REMARKS

APPENDIX

Annotated Marked-up Drawings

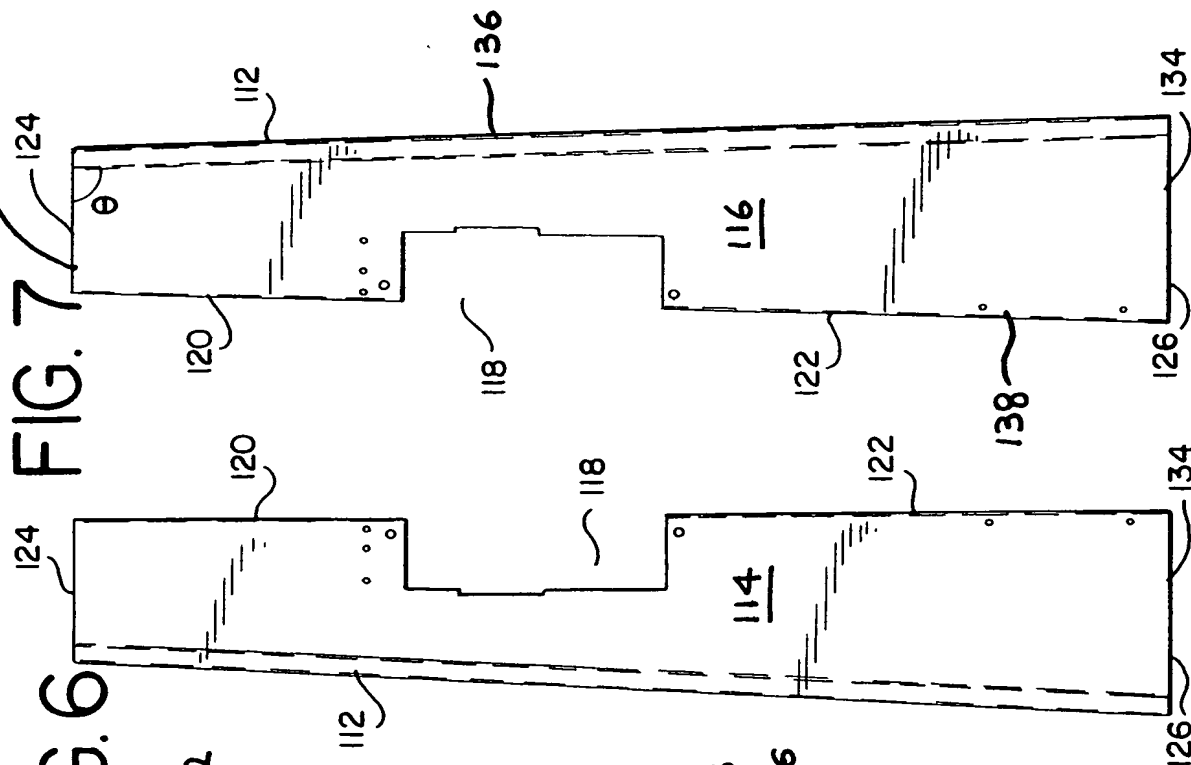
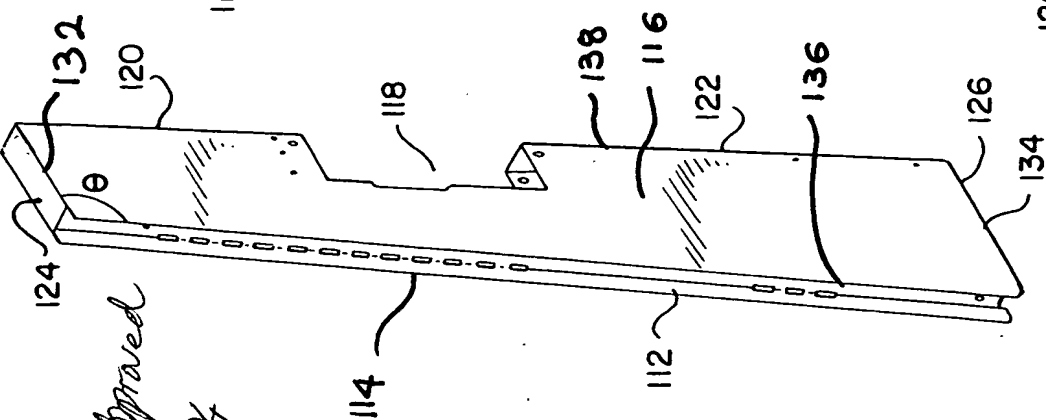
Third, the Office Action asserts that the inner wall 116 and the outer wall 118 are not identified in Figures 5-11, and that if the front wall 112 has been attached to the integral walls,

the attachment means is not described and it is not shown as a separate part. Applicants submit that the Office Action mislabels the “side wall 116” as the “inner wall 116,” “opening 118” as the “outer wall 118,” and the “front surface 112” as the “front wall 112.” Figures 5-11 have been amended to identify side wall 116. Figures 5-7 originally have identified the opening 118. Figure 9 has been amended to identify the opening 118.

Fourth, the Office Action asserts that the top stanchion surface 124 and the bottom stanchion surface 126 appear to be an upper and a lower edge of a side wall, respectively, in Figure 5. Applicants respectfully submit that the top stanchion surface 124 and the bottom stanchion surface 126 are not the edges of the side wall. Page 12, the last paragraph of the specification expressly describes that surfaces 124, 126 of the stanchion are not the edges of the stanchion as follows:

In addition, Applicants have amended Figure 5 to identify the edges 132, 134, 136 and 138 and distinguish them from surfaces. Applicants have amended Figures 5, 10 and 11 to identify the top and the bottom stanchion surfaces 124, 126. Applicants submit that top stanchion surface 124 and the bottom stanchion surface 126 indicate rectangular shaped areas, formed at the top and the bottom of the stanchion, respectively. The specification on page 11-12 describes the top and bottom stanchion surfaces as follows:
